HISTORIC RESOURCE EVALUATION ASSESSMENT REPORT

Project: Assessment of proposed AC Marriott hotel at 3466 Mission Inn Boulevard, Riverside CA 92501 on an adjacent lot adjoining the Central Fire Station / Fire Station No. 1 structure at 3420 Mission Inn Avenue, with a planned future exterior façade rehabilitation and Adaptive Reuse project

Document issue 13 January 2021

Historical Structure Evaluation / Assessment Report for the Record with Recommendations:

3.5 Summary of City meetings review comments, historic structure and site treatment

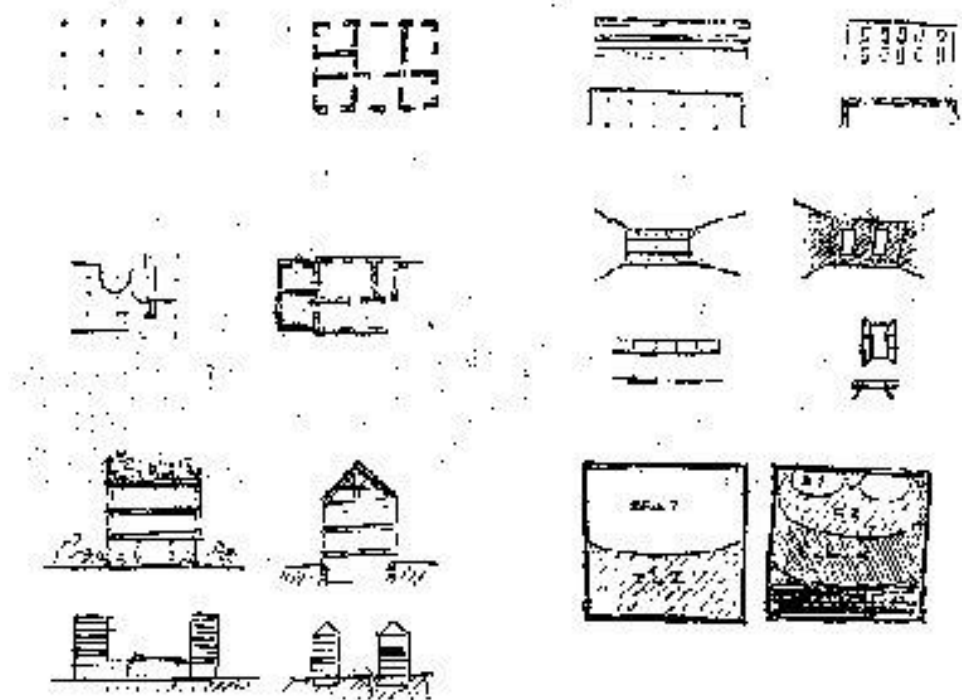
3.5.1 Reviewed the proposed design consisting of two- brands of hotels: Residence Inn (extended stay) and AC Marriott (more of a boutique/ European / modern “design-led” influenced hotel.) Total number of rooms is 225.

3.5.2 Height of structure is proposed to be a combination of seven and eight floors, minimal floor to floor height, with four underground parking levels.

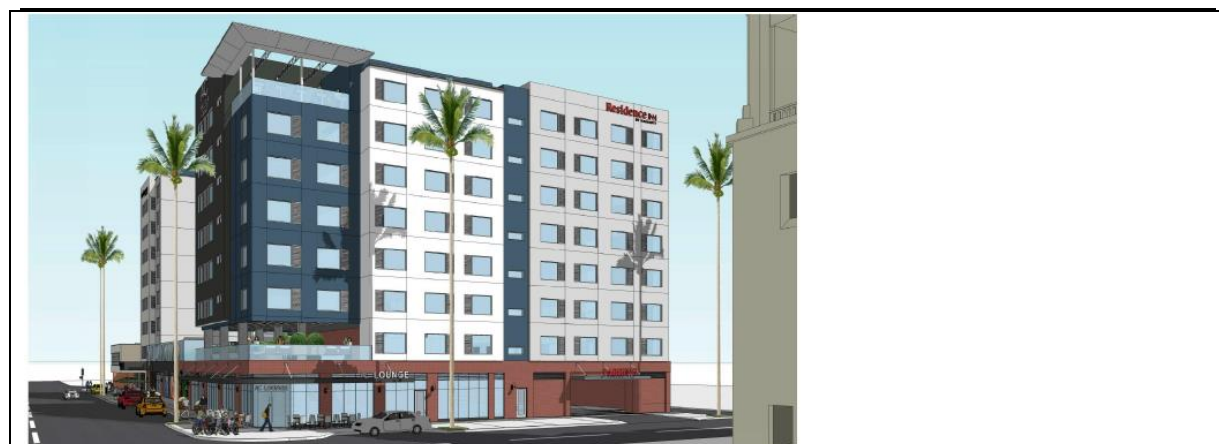
a>The thin diameter piloti columns of the Fire Station No. 1 appear to be widened; these are character – defining features where such alteration of dimension may prove problematic.

b>Color rendering of the Fire Station No. 1 surfaces does not reference the existing brick masonry and plaster surfaces.

c>Wall sconce light fixtures shown will require review of design, locations, extent, and finishes.

d>The appearance of the glazed apparatus garage door replacement is appropriate as schematically shown.

e>Clarify that the color of the Fire Station No. 1 second floor window framings will be referenced in the Hotel design.

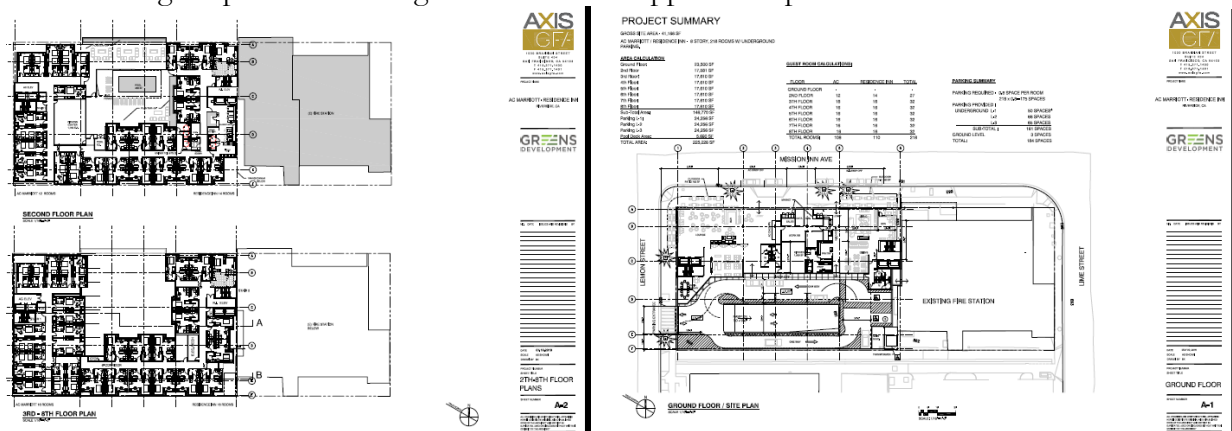
- 7.3.1: Horizontal datum lines created by the two-story volume of Fire Station No. 1 are continued across to the two-story plinth design of the proposed project. This two-story base design element references the masonry color and material in the Fire Station façade and will reinforce a compatible tie into the proposed design adjacent to the existing landmark. The datum lines of existing floors, roofs and window sills are transposed across from the proposed design;

- 7.3.2: The brick masonry façades of the Fire Station No. 1 are referenced at the ground floor level of the proposed project, continuing similarities of color, texture and character;
